# ALERT SERVICE BULLETIN

**TIME LIMITS - MAINTENANCE CHECKS - Cabin windows**  
**Improvement to the window jettisoning system**  
 ATA 56

This ALERT SERVICE BULLETIN consists in improving the jettisoning system for the windows which can be jettisoned from inside the cabin, by applying PTFE skived film to the intersection of the window frame and the seal of jettisonable windows.

The purpose of revision 2 is to supersede compliance with this ALERT SERVICE BULLETIN for helicopters which embody modification 332P087142.00.

Figure 1: Application of PTFE skived film around the window frame

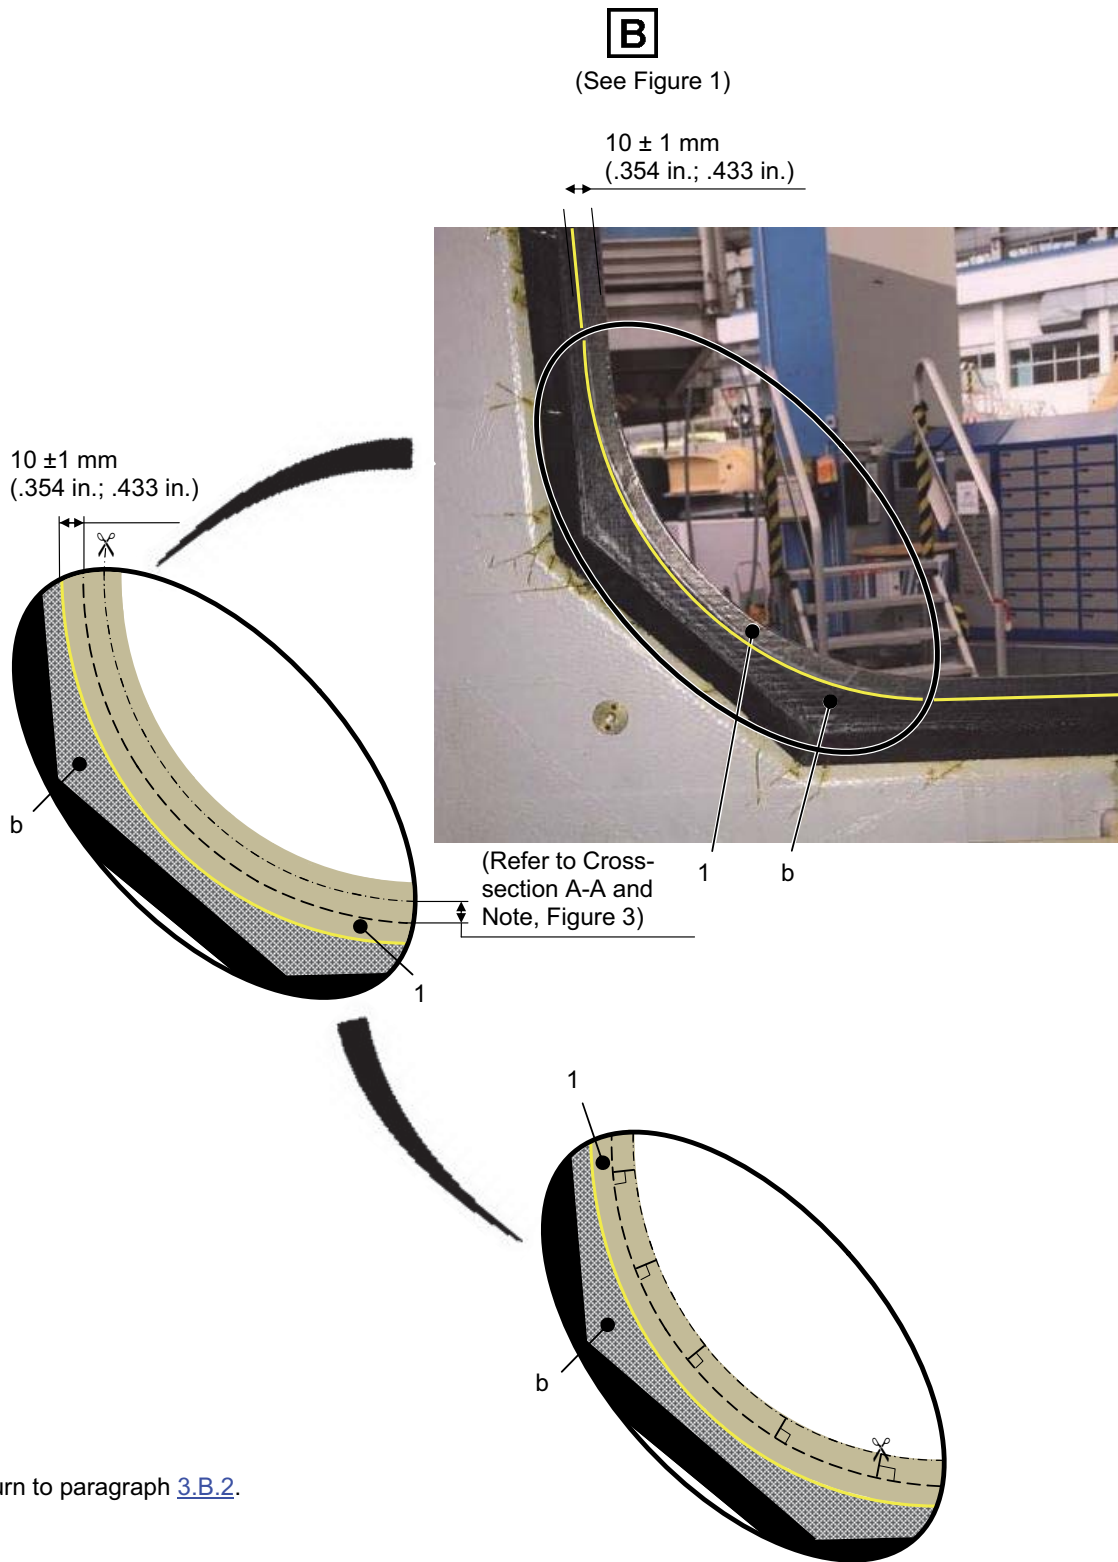
- Clean the inner and outer surfaces of frame (b) of window (a) (Detail B, [Figure 2](#)), as per MTC Work Card 20.04.01.402.
- Trace a line "R" on the inner surface of frame (b) (e.g.: using a marker) at 10 mm (.393 in.) from the edge (see [Figure 1](#)), which materializes the external edge of PTFE skived film (1) all around the frame.
- Bond PTFE skived film (1) to the inner surface of frame (b) (Cross-section A-A, [Figure 1](#)), taking care:
  - . to start bonding at seal joint "E" or "F" on the frame (see [Figure 1](#)),
  - . to line up with the previously traced contour line (see [Figure 1](#) and Detail B, [Figure 2](#)),
  - . not to create any wrinkles during the bonding procedure,
  - . not to cut off the PTFE skived film during the bonding procedure (see [Figure 4](#)).

*The PTFE skived film may be bonded in two pieces maximum, provided that their ends correspond with the seal joints "E" and "F" indicated in Figure 1.*

*Seal joints "E" and "F" must be located approximately halfway up the window frame.*

Figure 3: Bonding the PTFE skived film on the outside of the helicopter

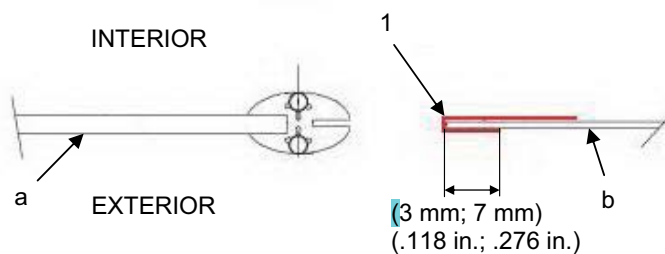
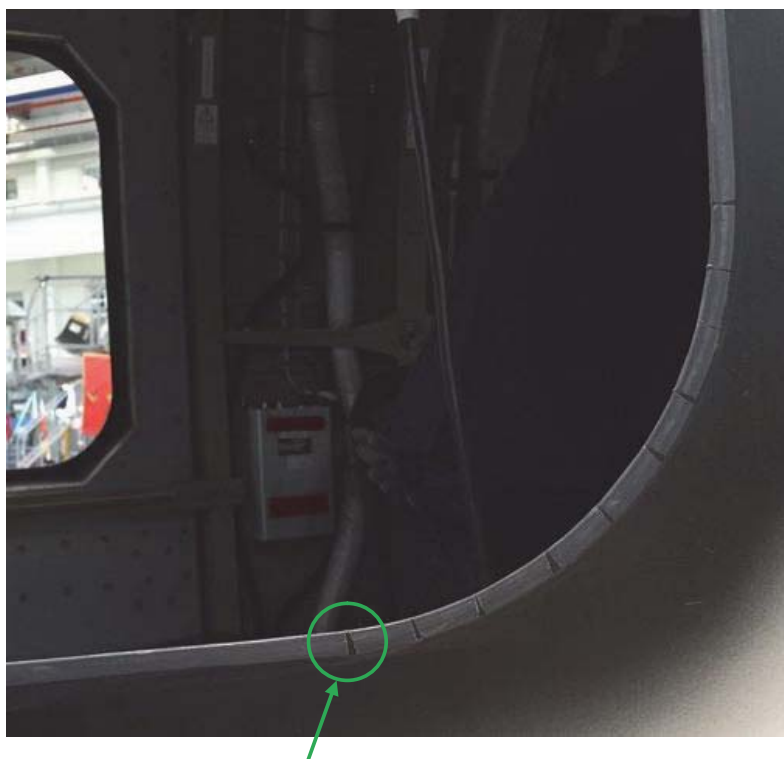
- Cut the width of the PTFE skived film which exceeds the window frame as indicated in Detail B, [Figure 2](#):
  - . leave a sufficient width to fold down the PTFE skived film onto the outer window frame (refer to the tolerances defined in Cross-section A-A, [Figure 3](#)).
- Make several cuts perpendicular to the structure in the PTFE skived film exceeding the frame, at each curve, as indicated in Detail B, [Figure 2](#).
- Fold down PTFE skived film (1) onto the outer window frame, taking care not to create any wrinkles (Cross-section A-A, [Figure 3](#)).
- Ensure that PTFE skived film (1) does not overlap as indicated (Detail B, [Figure 3](#)).

*The thickness of the frame, which may vary according to the helicopter, must be taken into account when cutting the PTFE skived film, in order to comply with the tolerances defined above.*
